**Campbell's Stores
Design Response**

Report prepared for Tallawoladah

Introduction Design Response Overview

This Design Response is submitted to the NSW Government Department of Planning to address public submissions to the EIS made during the period of public exhibition.

Figure 0.1 October 2015 EA Plan, with markups (in blue) locating submission comments

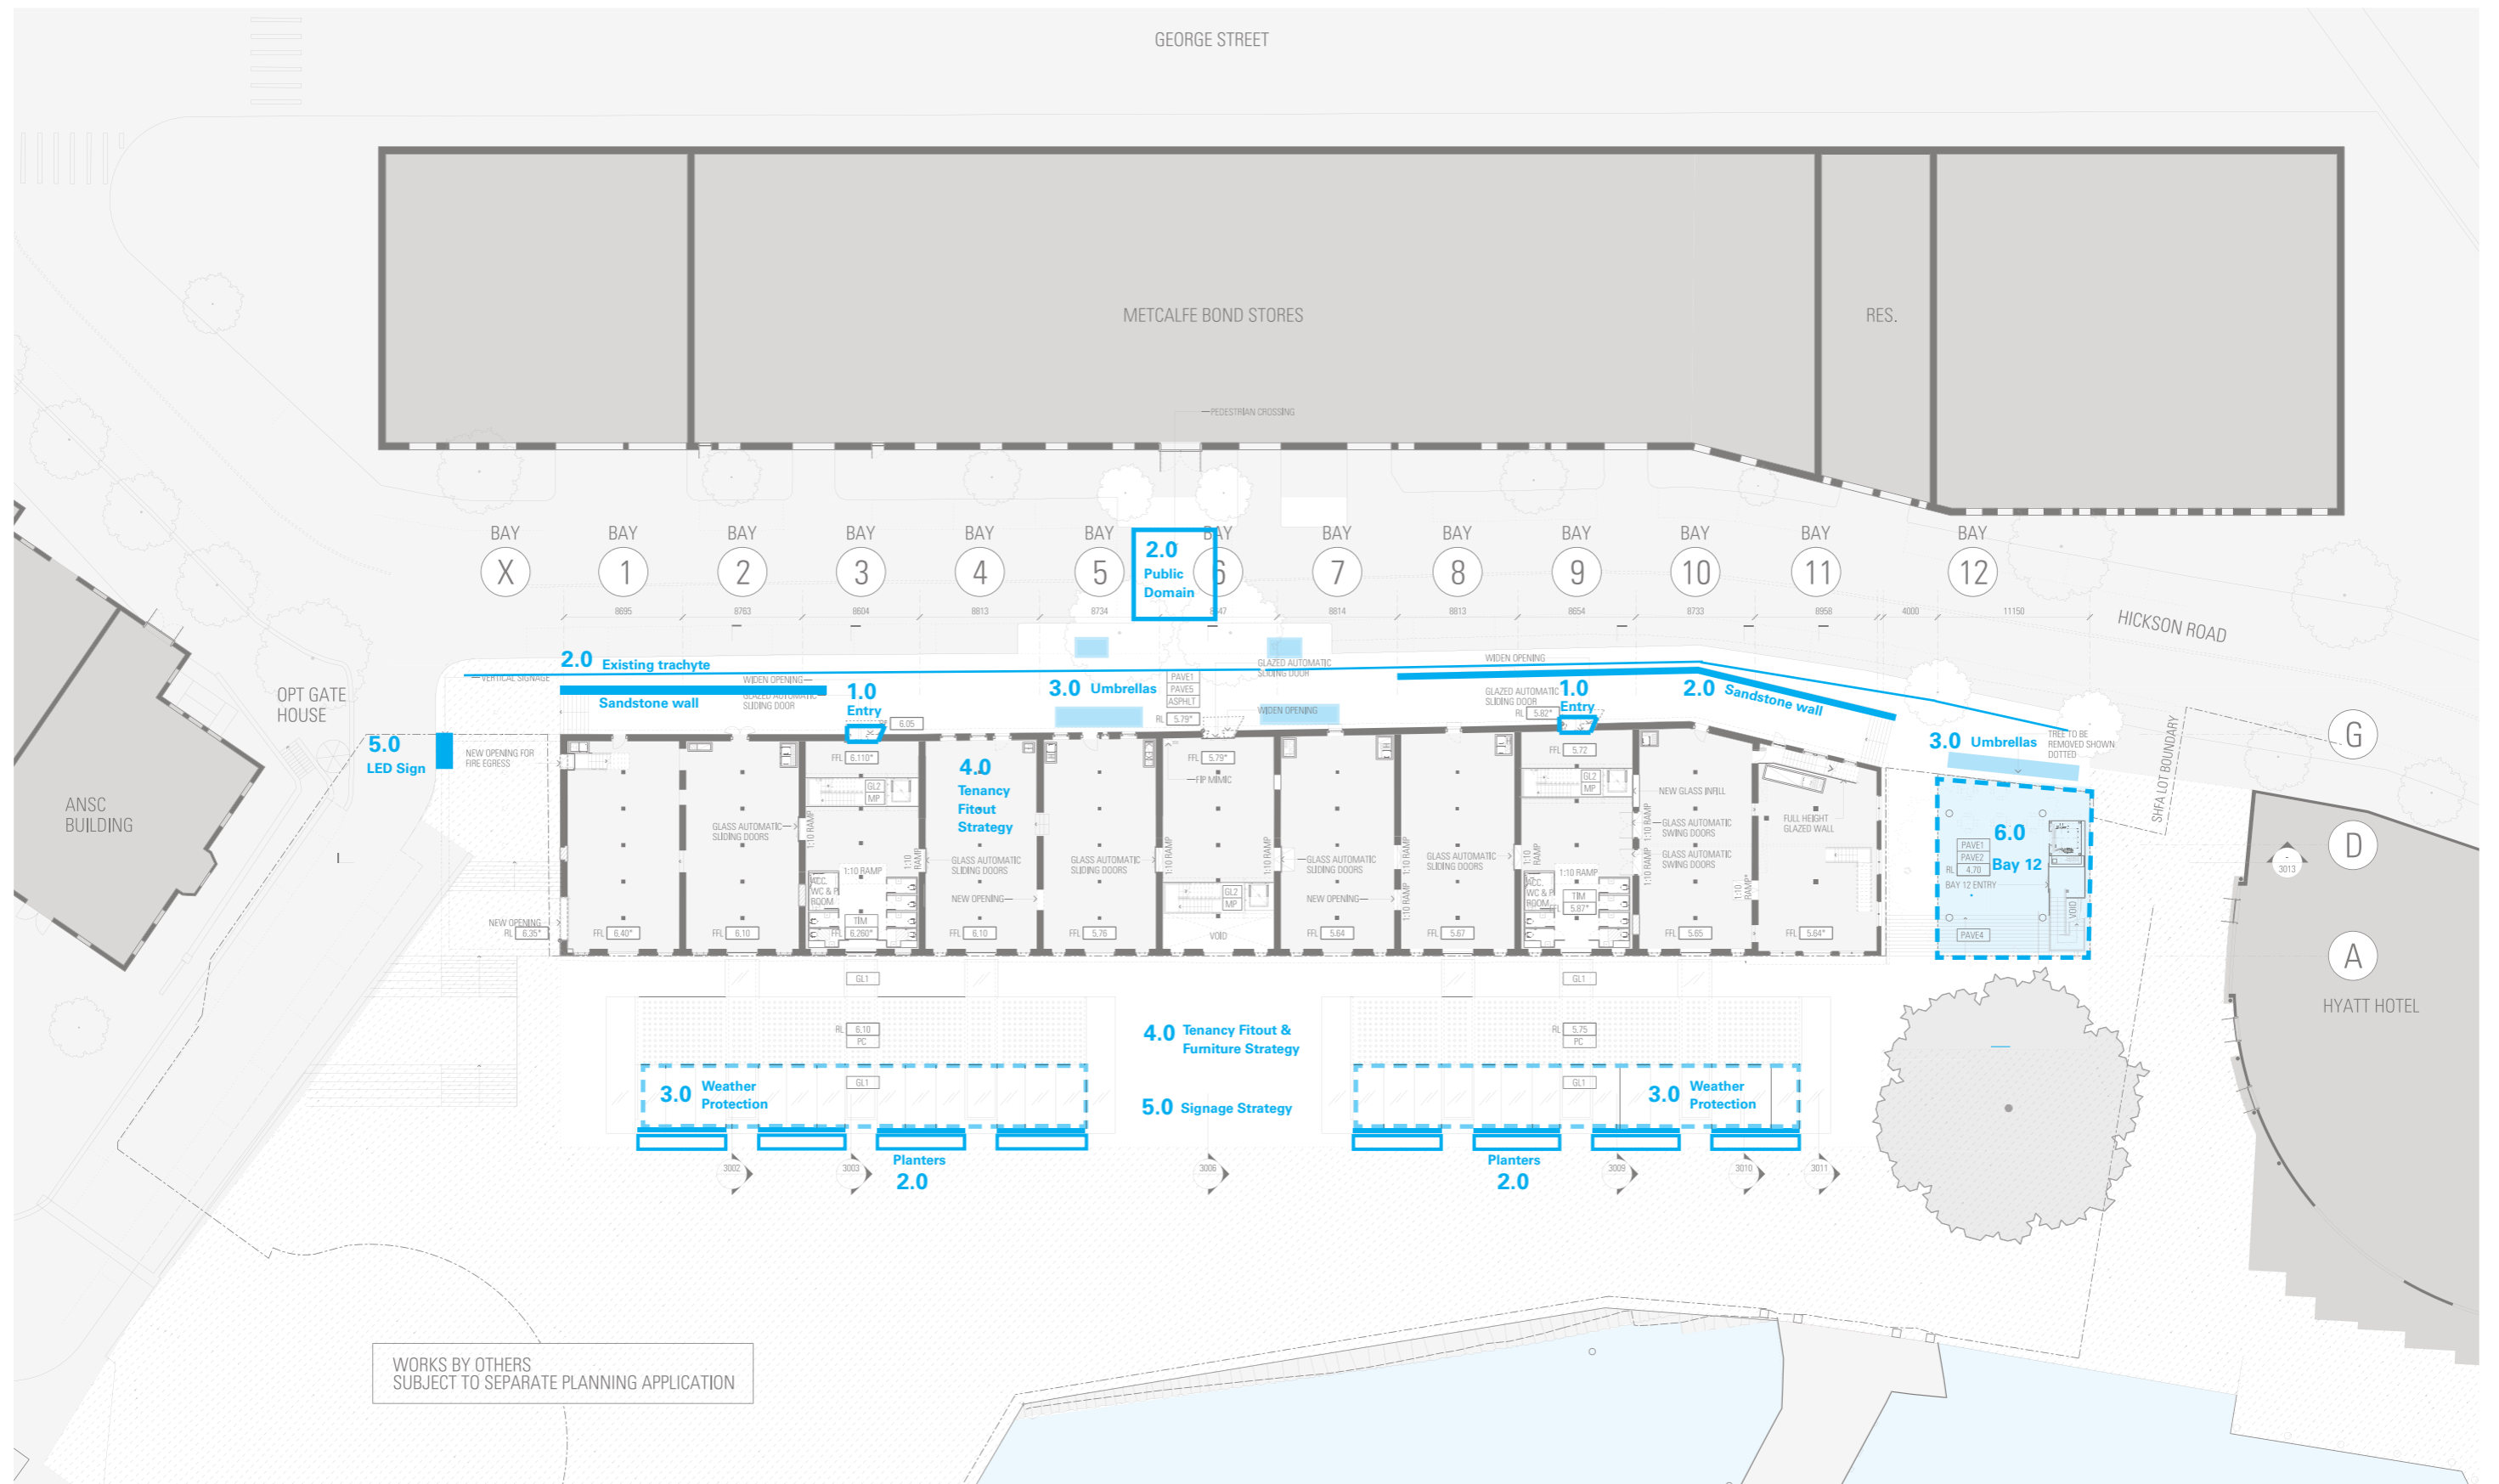
Chapter	Submission Comments	Agency	Design Response
1.0	HICKSON ROAD DOORWAYS		
	6. The new doorways in Bays 3, 6 and 9 of the west facade propose the removal of significant fabric and addition of new contemporary awnings in three locations that would diminish the architectural character of the west facade from Hickson Road to an unacceptable level. It is recommended that approval is granted to Bay 6 only as this is the public bay and would be symmetrically placed.	HC	• The design has been refined & more detail provided ✓

2.0	PUBLIC DOMAIN		
	7. The proposed removal of the existing sandstone wall along the western footpath of Hickson Road is not sufficiently justified in the EIS. The heritage significance of the existing wall should be assessed and the proposal should be modified to retain significant fabric.	HC	• The wall does not have heritage significance. Design has been clarified ✓

8. Trachyte kerbs are significant to The Rocks area and should be retained and displayed in situ as part of the proposed landscape works.	HC	• Agreed. The design has been modified ✓

11. The proposed contemporary new canopy above the forecourt dining area is supported as it would replace a series of intrusive canopies, and has been sensitively designed in accordance with the endorsed CMP to provide an appropriate physical and visual setting for Campbell's Stores. The separation between the Campbell's Stores building and the proposed canopy structure is a positive element that should be retained as open public passage and not be filled with outdoor seating. Detailed design of the forecourt should maintain the visual connection between the Stores and the waterfront by avoiding any permanent, delineating elements.	HC	• The planter boxes will be designed as precast, moveable elements. ✓

36. Footway widening to the west of the building is supported. However, the existing trachyte stone kerbs should be retained in-situ to reference the original kerb lines, as has been the approach for other roads within The Rocks and Millers Point Village. Notations on the Landscape Plan of "existing trachyte kerb removed and reused on site" are not acceptable to the City. New kerbs should be built to the City's specifications.	CoS	• Agreed. The design has been modified ✓

37. The use of cobbled stone for the proposed pedestrian crossing raises issues for general accessibility, especially for wheelchair users and visually impaired persons. Further detail is required on the proposed specification and finish of the cobbles.	CoS	• Agreed. Further detail has been provided in this submission ✓

3.0	WEATHER PROTECTION		
	2. It is requested that the RTS further consider the visual impacts of the proposal with regards to the Sydney Opera House Buffer Zone and also the recommendations made in the Wind Assessment. The RTS should update the photomontages as necessary.	DPE	• Further clarification and photomontages have been provided (refer Urbis' appendix) ✓

9. Outdoor seating on the western side of the Campbell's Stores is permitted only to the extent that it can operate without the need for any shade structures, temporary or permanent. Such shade structures are not permitted on this elevation.	HC	• Agreed. Umbrellas removed ✓

12. Any approval should exclude the installation of any shade structures on the western side of the proposed building in Bay 12. Such structures should be discouraged in future as well to avoid visual clutter leading to further permanent structures in this area.	HC	• Agreed. Umbrellas removed ✓

29. Whilst the design for the waterfront seating area is well intentioned in terms of transparency and openness, the existing weather protection infrastructure at the site, including plastic covers and solid awnings, is indicative of a future outcome. Should the proposed planter beds with retractable screens be ineffective and the clear glass awning not provide sufficient sun protection, which the City believes will be the case; a secondary layer of ad hoc weather protection is expected. Tenants having their own umbrellas below the awning or tenants having their own plastic side covers should be avoided (and would be counter to the Conservation Management Plan) by careful consideration at this stage through weather modelling and strengthening the defensiveness of the infrastructure.	CoS	• Agreed. The design of the new awnings includes a retractable sun-blind underneath the glass roof. Refer to Windtech's report in Urbis' submission. ✓

5.0	SIGNAGE STRATEGY		
	33. (Same as 33 above)	CoS	• As above ✓
	35. The large LED sign toward the south-western corner of the site is not supported and should be re-evaluated. It is not compatible with the heritage significance of the site and will compete with the Overseas Passenger Terminal vehicle access for attention. The sign appears 4-5m high and is said to be an interpretation of the location and dimensions of the original bay, now demolished. A low key, softly lit, sign respecting the heritage attributes of the site should be provided closer to the building, perhaps attached to the rebuilt low sandstone wall along Hickson Road. It also appears that the proposed sign is located on the Overseas Passenger Terminal land owned by Newcastle Ports Corporation. Any building signage should form part of a well-considered Signage Strategy, including matters raised in relation to the tenancy signage in this submission.	CoS	• Agreed. The LED sign has been removed, and the CoS recommendation adopted as part of the Signage Strategy. ✓

6.0	BAY 12		
	1. It is requested that the RTS further consider the design of the free standing building in Bay 12, particularly with regards to providing a more sympathetic relationship with the existing Campbell's Stores structures and the site's context.	DPE	• Agreed. Design has been modified. ✓

10. The Proposed contemporary new building (Bay 12) in the location of the existing northern pavillion is supported, however it must comprise high quality design and materials in accordance with the significance of Campbell's Stores and its prominent setting within the Rocks. Any significant archaeology in the location of Bay 12 should be retained in situ and incorporated into its detailed design.	HC	• Agreed. Section 60 process will be implemented per Archaeologist report. ✓

28. The roof and underside of the soffit to the northern "Bay 12" building need to be approached as fifth and sixth elevations of the building due to their high visibility from the public domain and surrounding buildings. The materials and finishes will need to be high quality. Glass floors or glass blocks in the floor of the building, visible to pedestrians looking up, is unlikely to be resolved satisfactorily. Lighting requires careful integration with the soffit. Public art opportunities are present.	CoS	• Agreed. These issues have been considered further and further detail provided ✓

30. Plans, elevation and renders are not aligned and require greater coordination. For example, the glass block finish for the "Bay 12" building is shown in the round in most images. However, internal renders show large slotted windows for views to the Opera House and back to Campbell's Stores. These slot windows have a very different architectural styling to the glass block vision. Clarification should be provided on the direction and objectives for the building.	CoS	• The slot windows have been removed. ✓

32. The internal renderings of the Bay 12 Building include clear glazed windows that indicate a framed view of the Opera House. The structure therefore is likely to block rather than share this view with properties to the west.	CoS	• Refer to Visual Impact assessment ✓

Figure 1.1 Detailed Design Refinements
Original design proposal (in red) compared to the revised design proposal for Bays 3 & 9 entries

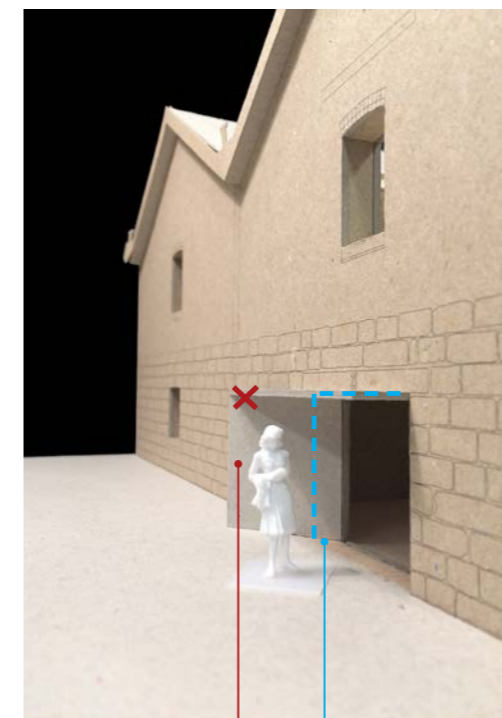
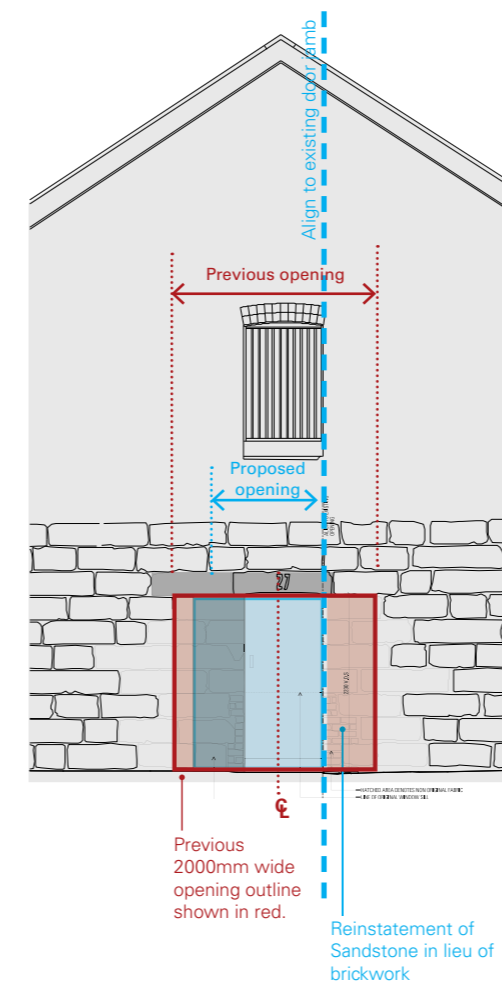
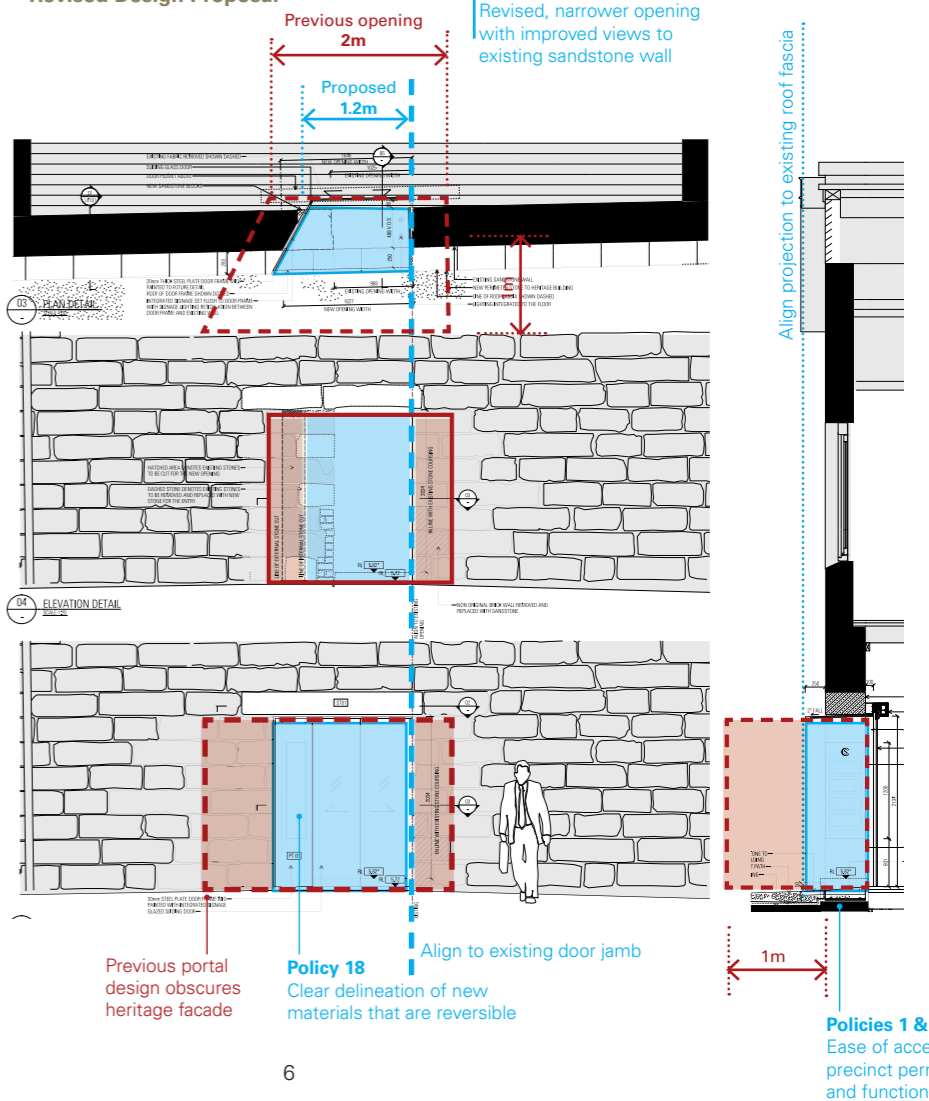
Submission Comments	Agency	Design Response
Design Modifications 6. The new doorways in Bays 3, 6 and 9 of the west facade propose the removal of significant fabric and addition of new contemporary awnings in three locations that would diminish the architectural character of the west facade from Hickson Road to an unacceptable level. It is recommended that approval is granted to Bay 6 only as this is the public bay and would be symmetrically placed.	HC	<ul style="list-style-type: none"> The doorway designs have been refined and reduced in size to specifically respond to the existing heritage conditions of each bay. Refer to summary in Figure 1.1, 1.6 & 1.7 Refer to new, detailed Architectural Drawings A4100-A4103 for detailed demonstration of the design sensitivity to heritage considerations, including retention of significant fabric ✓

- > Retain entrances in Bays 3, 6, & 9
- > Establish a hierarchy of entrances, with Bay 6 as a 'major' through site link entrance, and Bays 3 & 9 as 'minor' entrances (Fig. 1.6)
- > The width of the Bay 3 & 9 entrances to be reduced to 1200mm wide (from 2000mm) this is also the minimum recommended by the Fire Engineer for safe fire egress. (Fig. 1.1)
- > The projection of all of the portals be reduced in depth to 250mm (from 1000mm) to reveal more of the existing heritage elevation to the street. (Fig. 1.1)

Original projection of 1000mm obscures view to sandstone facade

Projection cut back to maximise visibility to sandstone facade

Figure 3.3 Warm grey and coffee colour fabric samples (above) Museum of Sydney forecourt awnings used as colour precedent (below). The colour should be visually recessive in accordance with the CMP.

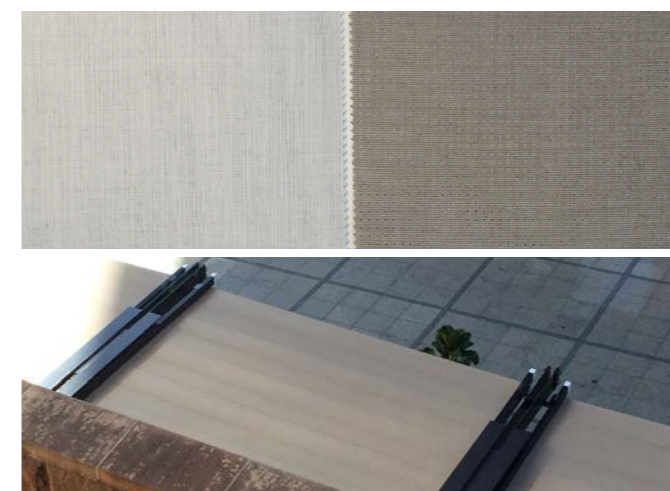
29. Whilst the design for the waterfront seating area is well intentioned in terms of transparency and openness, the existing weather protection infrastructure at the site, including plastic covers and solid awnings, is indicative of a future outcome. Should the proposed planter beds with retractable screens be ineffective and the clear glass awning not provide sufficient sun protection, which the City believes will be the case; a secondary layer of ad hoc weather protection is expected. Tenants having their own umbrellas below the awning or tenants having their own plastic side covers should be avoided (and would be counter to the Conservation Management Plan) by careful consideration at this stage through weather modelling and strengthening the defensiveness of the infrastructure.	CoS	<ul style="list-style-type: none"> Agreed. The design of the new awnings includes a retractable sun-blind underneath the glass roof. Details of the fabric and a precedent example are given in this submission (refer item 3.2 Sunshading clarification) Refer to Windtech report for statement regarding the suitability of the weather protection infrastructure

The proposed colour of the fabric will be a 'warm' colour such as a warm-grey or coffee colour (Fig. 3.3). The fabric will be partially translucent (not fully opaque), so that (when in use) it can afford silhouetted views through to the heritage facade, from the external seating areas. To ensure these aims are met, a sampling and visual mockup/prototyping process will be specified to control the quality and appearance.
